AMENDMENT/ADDENDUM No. 1

Solicitation Number: 2021-44VS

Description: GSFH Cooling Tower Replacement

STORAGE TANK DETAIL
SCALE: NONE.

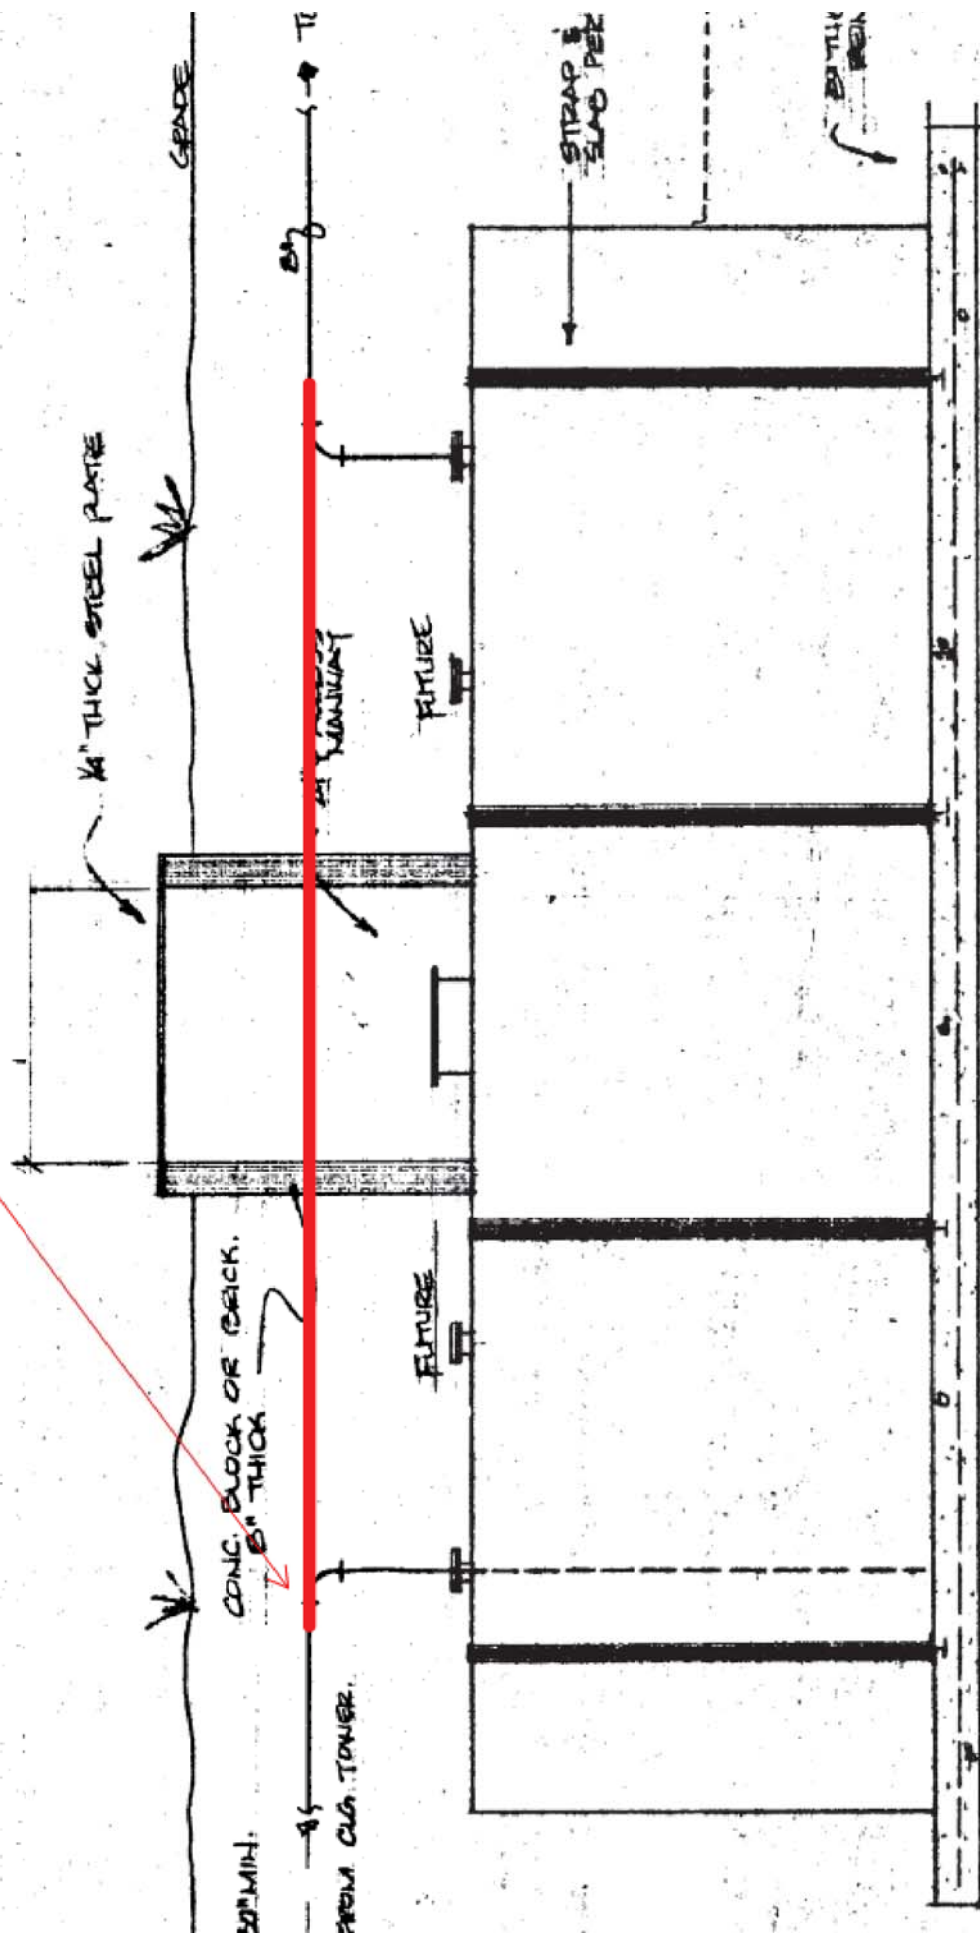
5. CMI will provide separate variable speed drives for control of each cooling tower fan motor.
6. During the site visit, discussion was held regarding the existing underground storage tank. Attached are snapshots from the record drawings that show the tank location and piping. For bid purposes, the Contractor shall assume installing the bypass pipe as shown. The Contractor shall also assume that the piping connections shown are accessible. Include survey/investigative work necessary to identify the location of the tank in the bid price. Assume the piping connections to the tank are accessible without moving other equipment to access. Bypass pipe shall be 8" schedule 80 PVC.
7. Bid Opening Date has been changed to Thursday, March 18, 2021. Time remains the same.

REMOVE ELBOWS AND INSTALL
BYPASS ACROSS TANK. CAP
EXISTING RUNOUTS TO TANK.
FILL TANK WITH SLURRY.

1 COOLING TOWER WIRING DIAGRAM

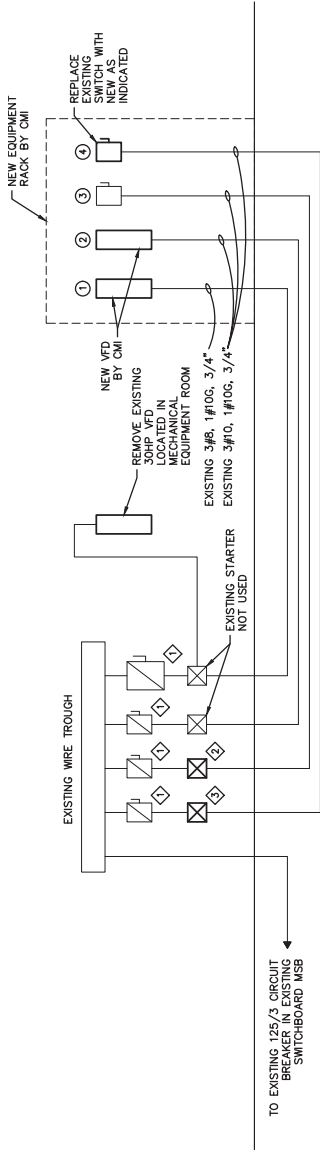
3. Refer to power wiring diagram to clarify scope of work associated with cooling tower replacement.
 4. Cooling tower shall be provided with 15KW basin heater.

- ① REPLACE EXISTING FUSES WITH NEW AS REQUIRED.
- ② REPLACE EXISTING MOTOR STARTER WITH NEW AS REQUIRED FOR NEW 7.5 HP PUMP.
- ③ REPLACE EXISTING HEATER CONTACTOR WITH NEW 30AMP CONTACTOR.
